UNITED STATES PATENT AND TRADEMARK OFFICE

APPLICATION NO.	FILING DATE	FIRST NAMED INVENTOR	ATTORNEY DOCKET NO.	CONFIRMATION NO.
10/630,457	07/29/2003	Kayoko Shibata	P/126-222	9037
2352	7590	11/04/2004	EXAMINER	
OSTROLENK FABER GERB & SOFFEN 1180 AVENUE OF THE AMERICAS NEW YORK, NY 100368403			NGUYEN, DANG T	
			ART UNIT	PAPER NUMBER
			2824

<p align="center">Office Action Summary</p>	Application No. 10/630,457	Applicant(s) SHIBATA ET AL.	
	Examiner Dang T Nguyen	Art Unit 2824

DETAILED ACTION

Fig. 17 of Funaba teaches both the buses and the terminal resistors are part of the memory modules.

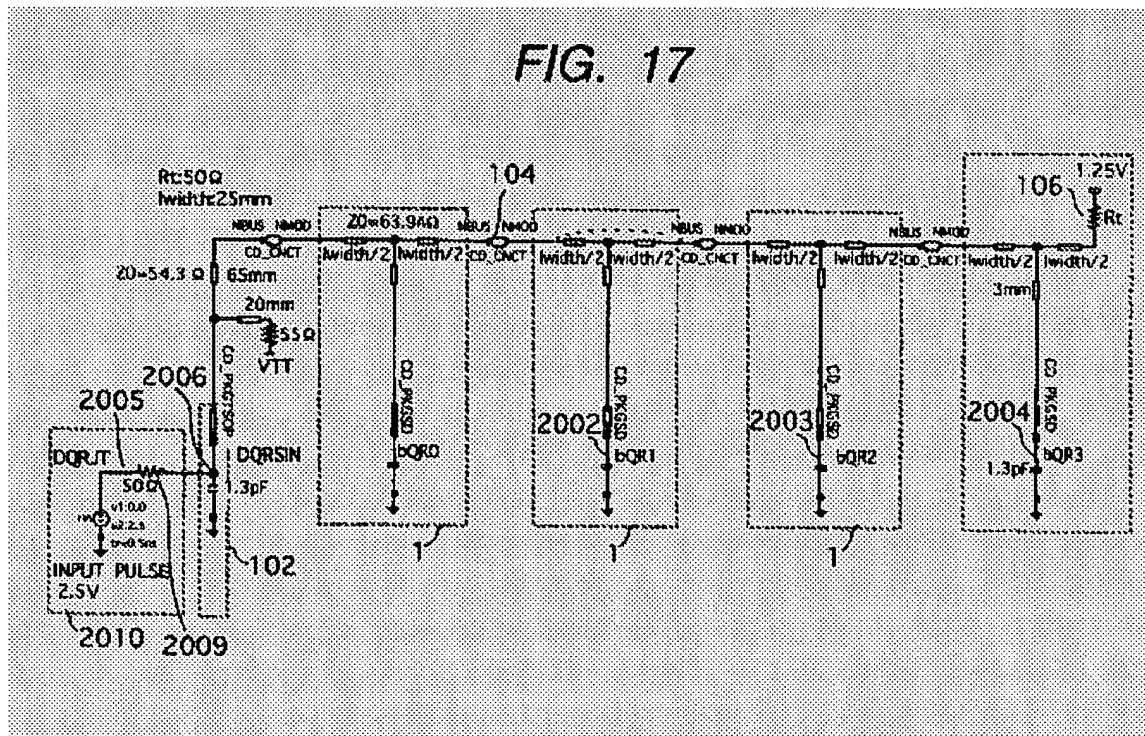
Examiner agrees with the Applicant that the reference of Funaba (Fig. 11) shows both the bus and the terminal resistors are on the motherboard, and not part of the memory modules. However, the structural limitation as recited in the independent claims 1 and 8 do not implicitly disclose or teach that the bus and the terminal resistors as a part of the memory module. Note that the 102 rejection is applied to the claim not the specification. Therefore, the argument is not persuasive.
